Minor/Minor Site Review for New Detached Single Family Dwelling, All Purpose Building Permit Application

BUILDING PERMIT REPORT
	DATE: 10 Augus Toba LADDRESS Plymouth ST. CBL: 345-A-611
	REASON FOR PERMIT: To Construct a 28 x 40 Single family duding & She
	BUILDING OWNER: Greater Habital For Humanity
	PERMIT APPLICANT: /CONTRACTOR Hab. ToT for Humanin
	USE GROUP: <u>B-3</u> CONSTRUCTION TYPE: <u>5</u> B CONSTRUCTION COST: <u>63100.</u> OPERMIT FEES: <u>462.</u> 0.
1	The City's Adopted Building Code (The BOCA National Building Code/1999 with City Amendments) The City's Adopted Mechanical Code (The BOCA National Mechanical Code/1993)
•	CONDITION(S) OF APPROVAL
	This permit is being issued with the understanding that the following conditions shall be met: $\frac{1}{2}$

#### CITY OF PORTLAND, ME BOCA 1999 Plan Review Record One and Two Family Dwelling

# CITY OF PORTLAND, MAINE DEVELOPMENT REVIEW APPLICATION PLANNING DEPARTMENT PROCESSING FORM

SITE PLAN

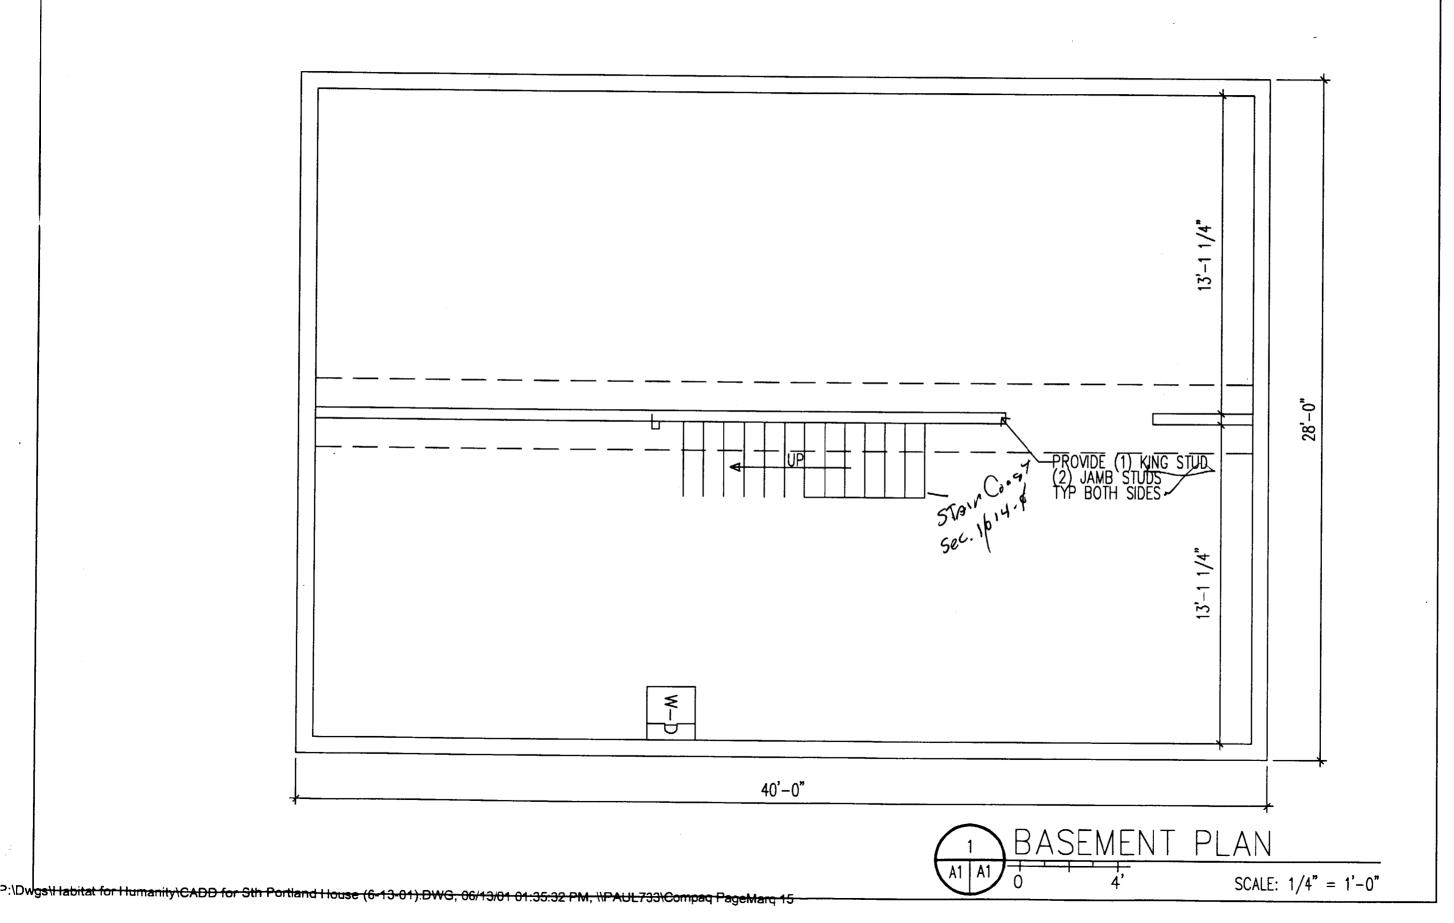
- 1 THERE ARE MINIMAL CHANGES IN PROPOSED GRADE (JUST AROUND FOUNDATION). ANY FUTURE CHANGES IN THE APPROVED SITE PLAN MUST BE RE-SUBMITTED TO THE CITY FOR REVIEW AND APPROVAL.

- 2 THE SEWER CONNECTION TO THE CITY SYSTEM MUST TIE INTO THE 8" PIPE, AS OPPOSED TO INTO THE MANHOLE.
- 3 All damage to sidewalk, curb, street, or public utilities shall be repaired to City of Portland standards prior to issuance of a Certificate of Occupancy.

- 10 The site contractor shall establish finish grades at the foundation, bulkhead and basement windows to be in conformance with the first floor elevation (FFE) and sill elevation (SE) set by the building contractor to provide for positive drainage away from entire footprint of building.
